SUNDRY NOTICES AND REPORTS ON WELLS

1. Type of Well: ☑ Oil Well ☐ Gas Well ☐ Other	5. Lease Serial No. NMNM0251
	6. If Indian, Allottee or Tribe Name
	7. If Unit of CA/Agreement, Name and/or No.
	8. Well Name and No. BIG EDDY UNIT 11
2. Name of Operator CHEVRON U.S.A. INC. Contact Bob Holden E-Mail rholden@keyenergy.com	9. API Well No. 30-015-20092
3a. Address 15 SMITH ROAD MIDLAND, TX 79705 — 3b. Phone No. *(include area code)* 432-209-7374	10. Field and Pool or Exploratory Area BIG EDDY DELAWARE
4. Location of Well *(Footage, Sec., T.,R.,M., or Survey Description)* Sec 7 T20S R31 E Mer NMP 1650FSL 660FEL	11. Country or Parish, State EDDY COUNTY, NM

Permanent Abandonment of Federal Wells
Conditions of Approval

Wellbore Diagram

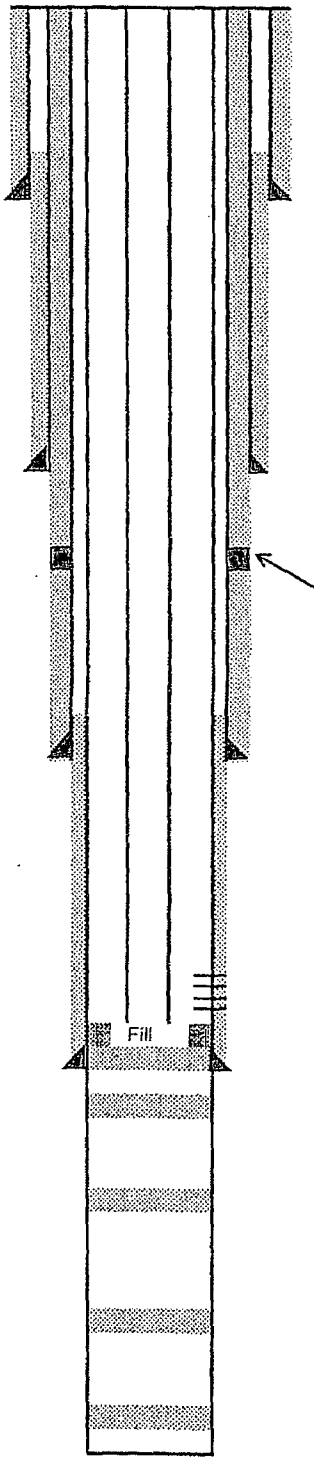
R-111-P Potash
Solid Plug 2950' – 468'
May require perf/sqz in stages. WOC tag.

At cut-off verify cmt to Surface all annulus.
